# 1981 Corvette: Service Bulletin: Whistle or Whine in Reverse or Lo 1 at Idle - THM 350C (MX3)

**Model and Year:** 1981 Corvette with THM 350C (MX3)

**Bulletin No:** 81-T-20

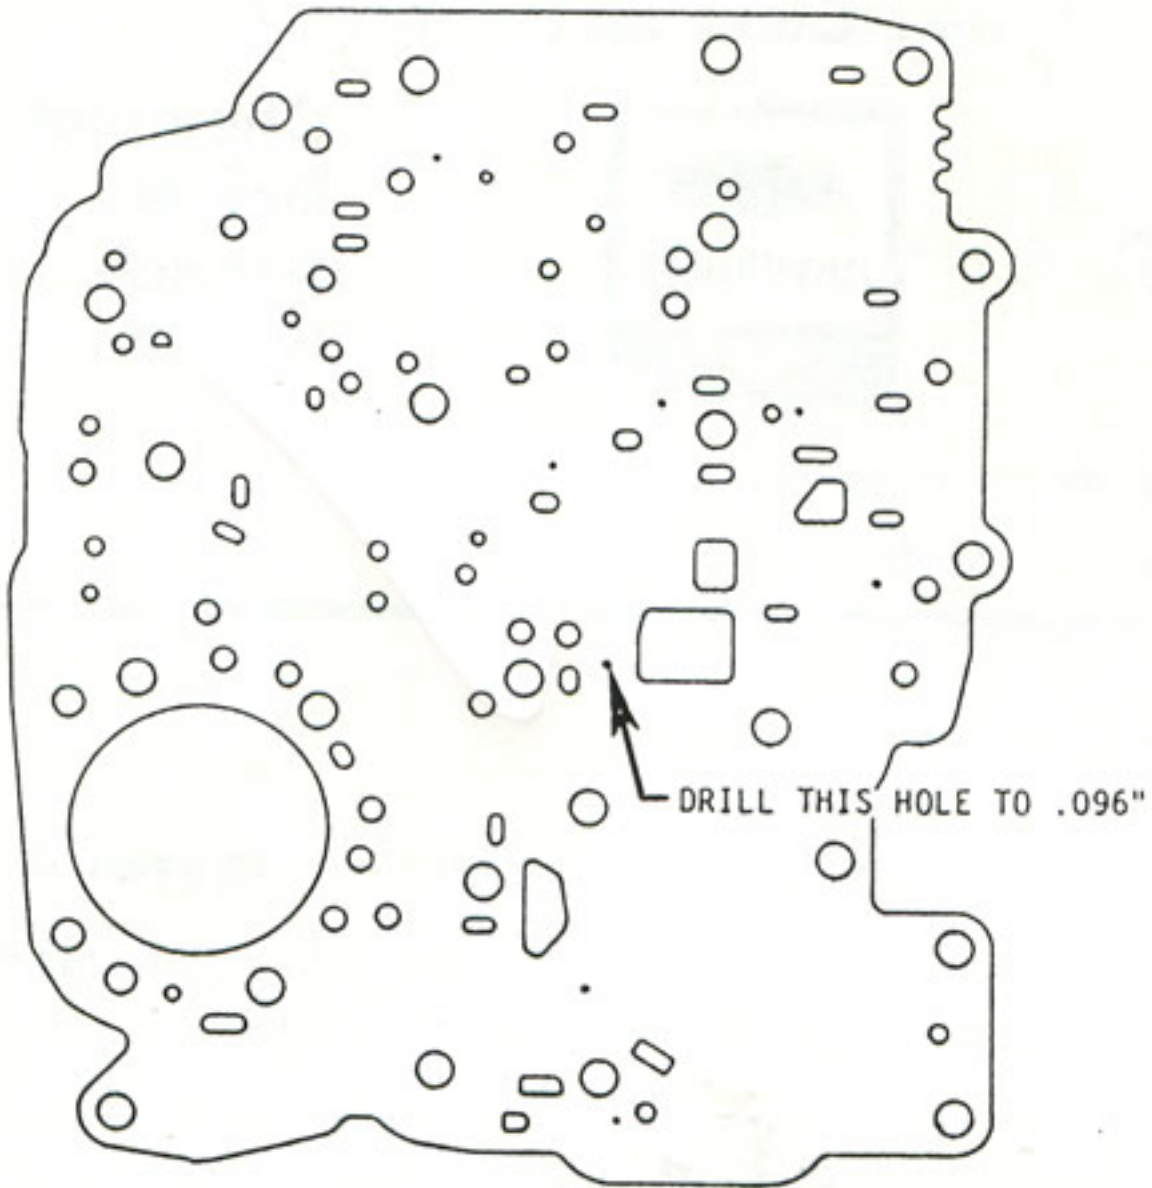
Some 350C transmissions in 1981 Corvettes and Camaros may emit a whistle or whine in Reverse or Lo1 at base idle. This is caused by the valve body spacer plate hole shown in the illustration.

To correct noise, enlarge the hole using a No. 41 drill (.096) and remove any burrs formed on either side of the plate.
